June 21, 2017

RE: Post-mining land use change and bond release for a portion of South Fork
Breakout Area - Canyon Fuel Company, LLC, Skyline Mine, C/007/0005

Title: Post-mining land use change for a portion of South Fork Breakout

Shalom Hazard Fuels Project Timber Sale #3 Mine

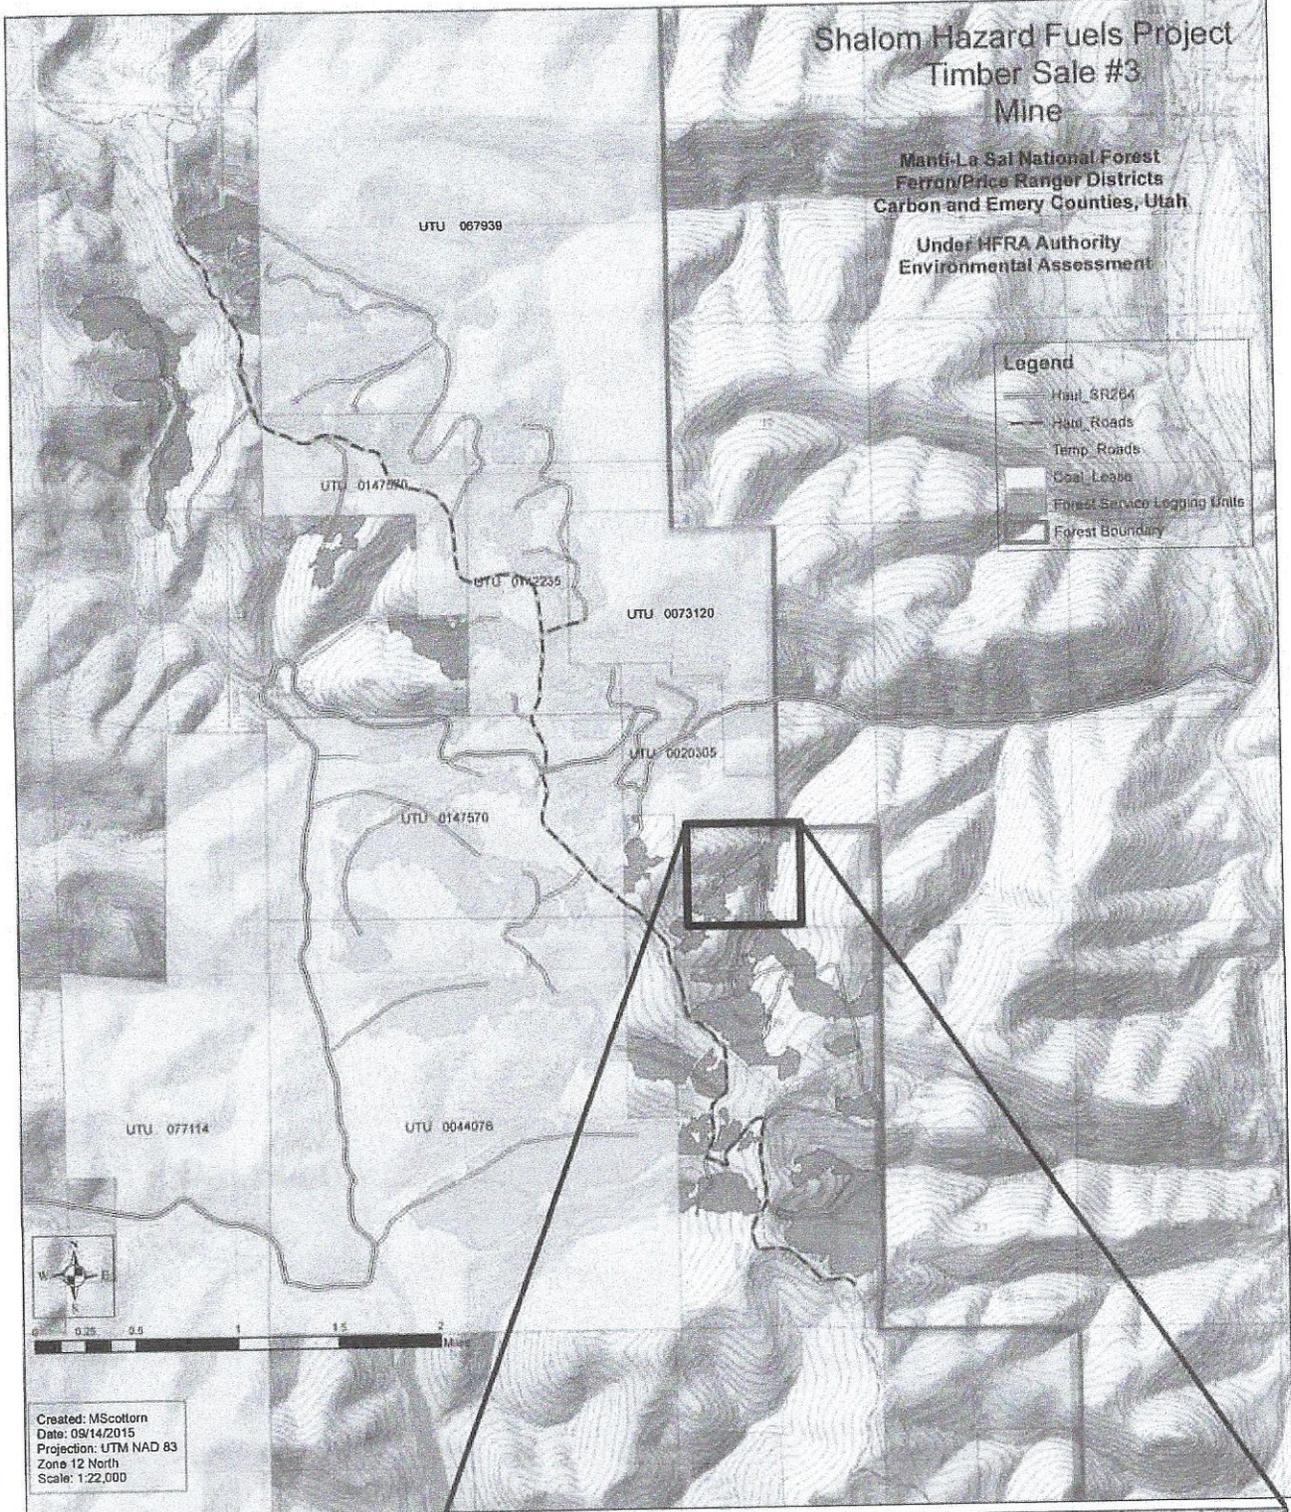
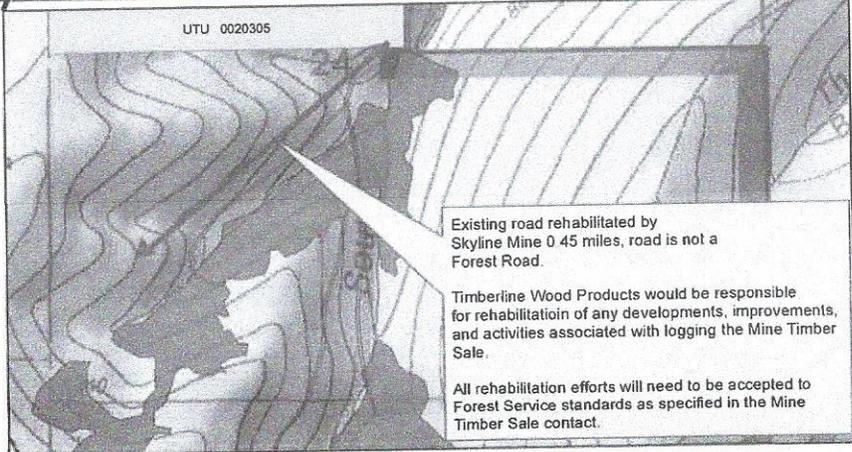
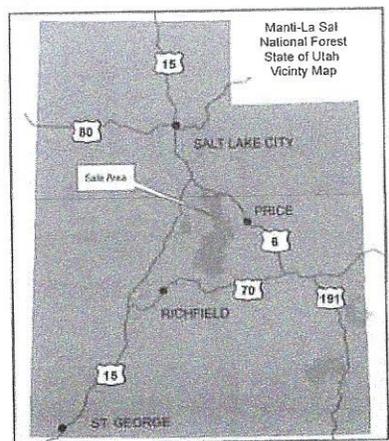
Existing road rehabilitated by Skyline Mine 0.45 miles, road is not a Forest Road.

Timberline Wood Products would be responsible for rehabilitation of any developments, improvements, and activities associated with logging the Mine Timber Sale.

All rehabilitation efforts will need to be accepted to Forest Service standards as specified in the Mine Timber Sale contract.

SCALE: 1" = 2000'	DATE: 9/24/01	CK.BY: G. Galecki	REVISION: 11
DWG. NO.: 1.6-3		DR.BY: JLP/CDH	
CAD FILE: 1.6-3REV9_4-6-15			06/21/2017

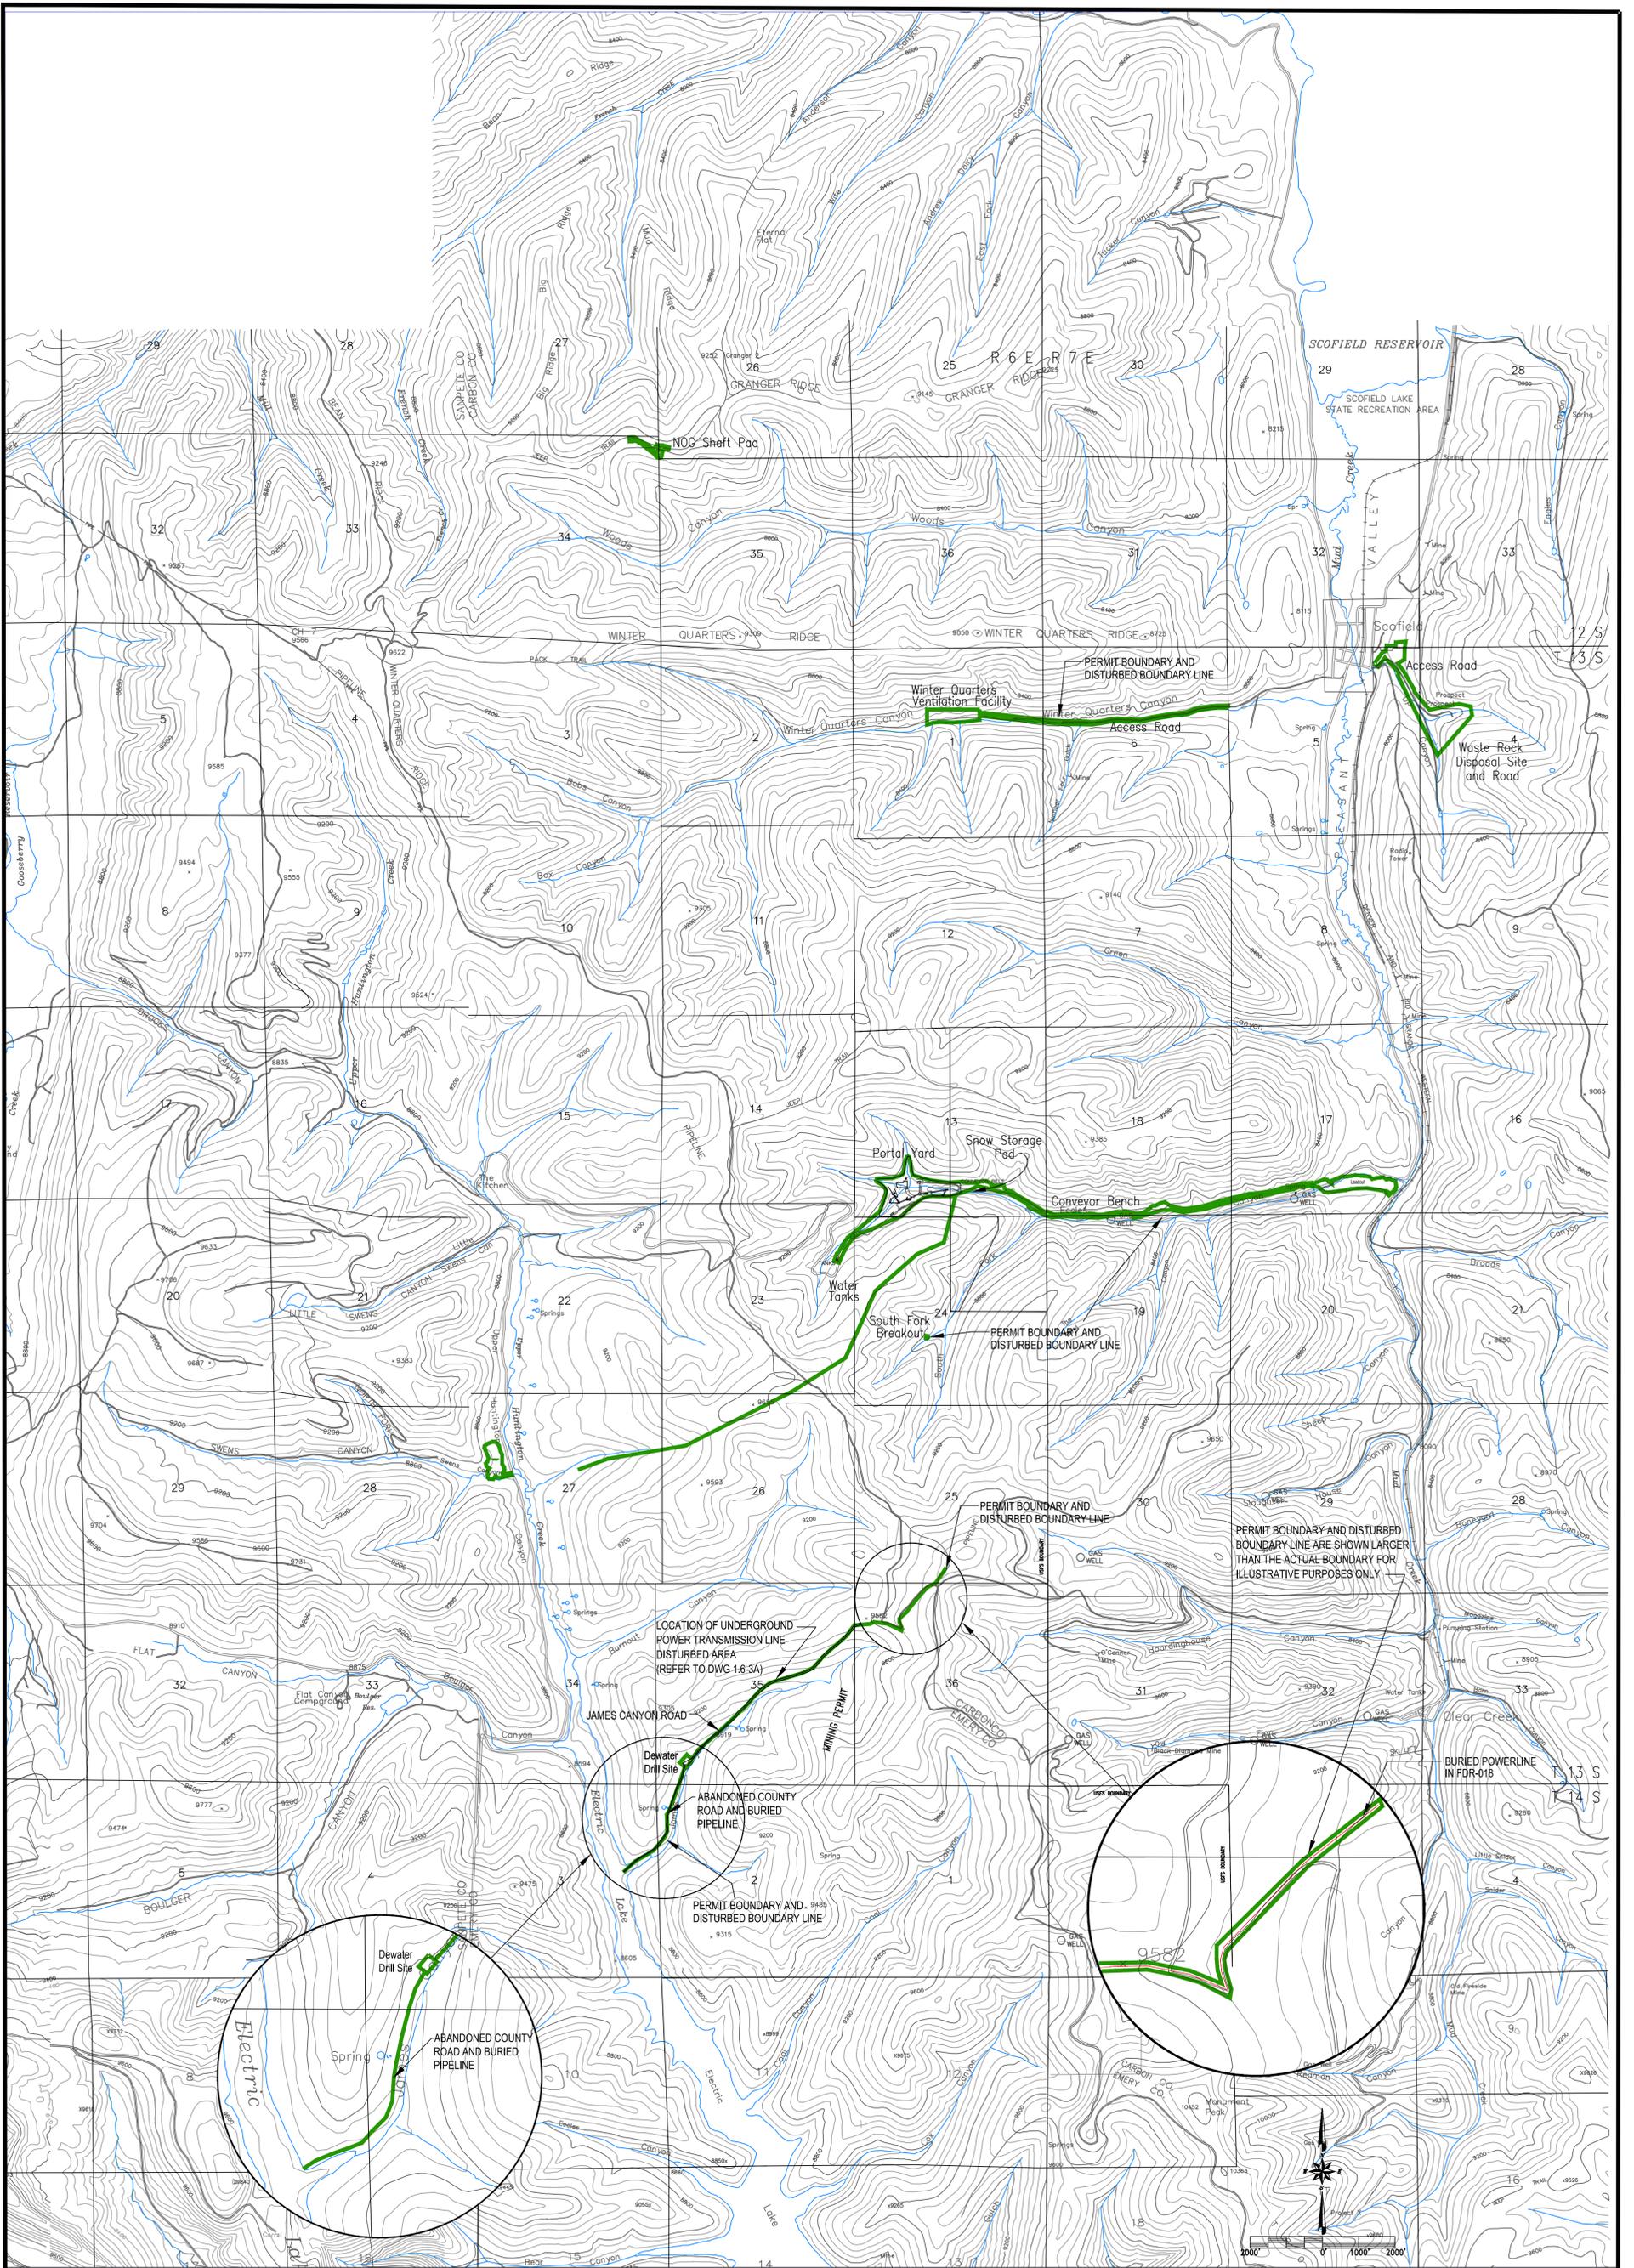
DATE	No.	REVISIONS	BY
AUG 02	1		JSM
NOV 02	2		JSM
JUNE 07	3	MODIFIED PERMIT BOUNDARY (BC & WASTE ROCK) SKYLINE MINES PERMIT AREA, LEASE AREAS.	BR/GC
MAR 2010	4	ADDED ADJACENT AREA, MODIFIED PERMIT AND LEASE BOUNDARIES	AB/GC
JUL 2010	5	ADDED WINTER QUARTERS ACCESS ROAD	AB/GC
AUG 2010	6	ADDED ADJACENT AREA	AB/GC
OCT 2012	7	Modified Adjacent Area with Lease Mod. and Relinquishments	GG/GC
July 2014	8	Corrected permit boundary to include water line from Tanks	GG/GC
April 2015	9	Added the NOG shaft pad	TE/GC
DEC 2015	10	Added Swens shaft pad and power line	JA/GC
JUN 2017	11	Remove So. Fork Road - change in post-mining land use	JA/GC

COASTAL STATES ENERGY COMPANY
SKYLINE PROJECT
SKYLINE MINE No. 1
PORTAL BREAKOUT AREA
DWG. No. 8 OF 21
MAP OR FIGURE NO. 3.2.11-1 REV 1

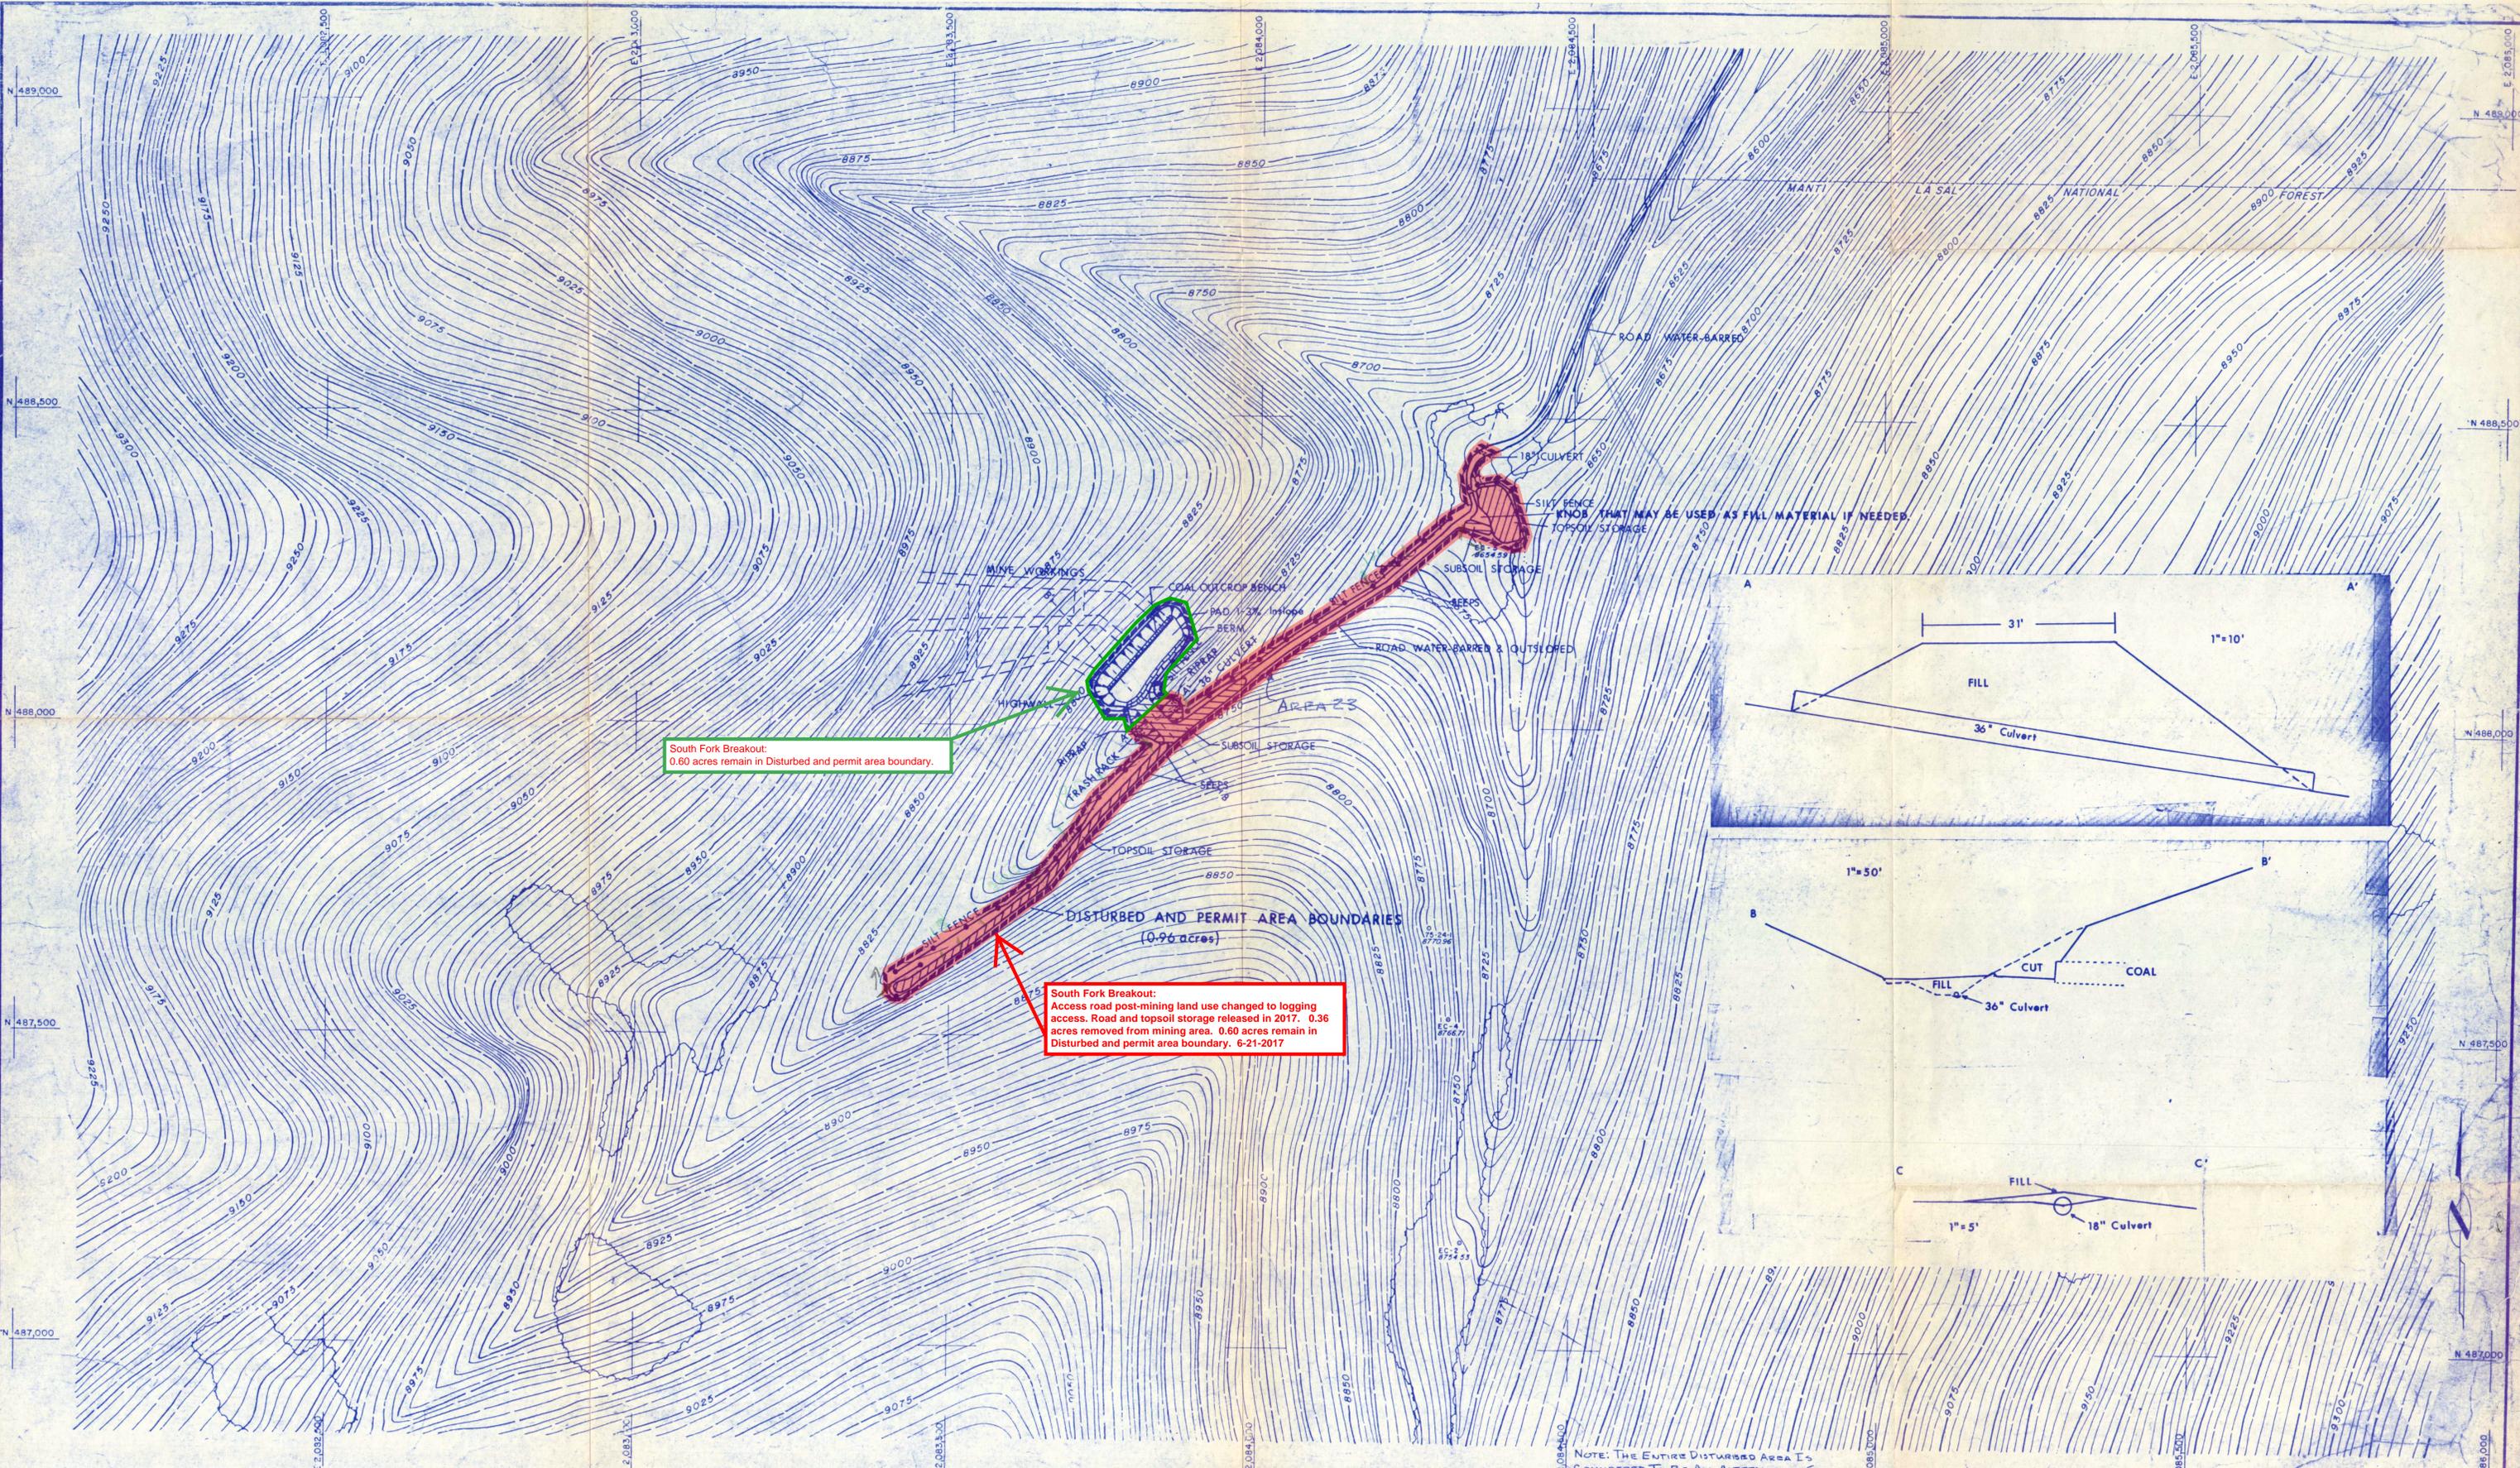
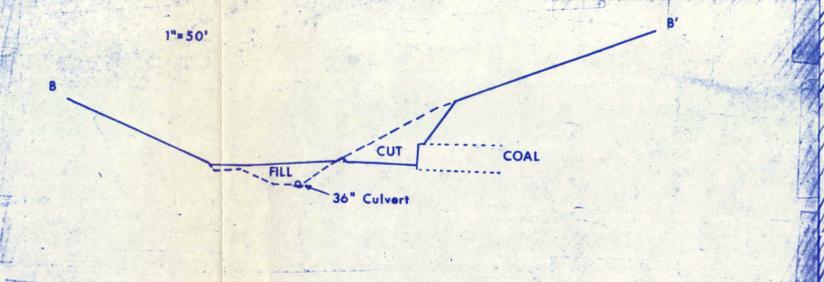
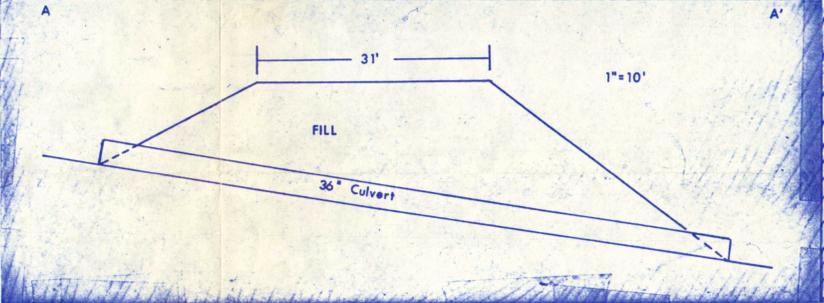
South Fork Breakout:
0.60 acres remain in Disturbed and permit area boundary.

South Fork Breakout:
Access road post-mining land use changed to logging access. Road and topsoil storage released in 2017. 0.36 acres removed from mining area. 0.60 acres remain in Disturbed and permit area boundary. 6-21-2017
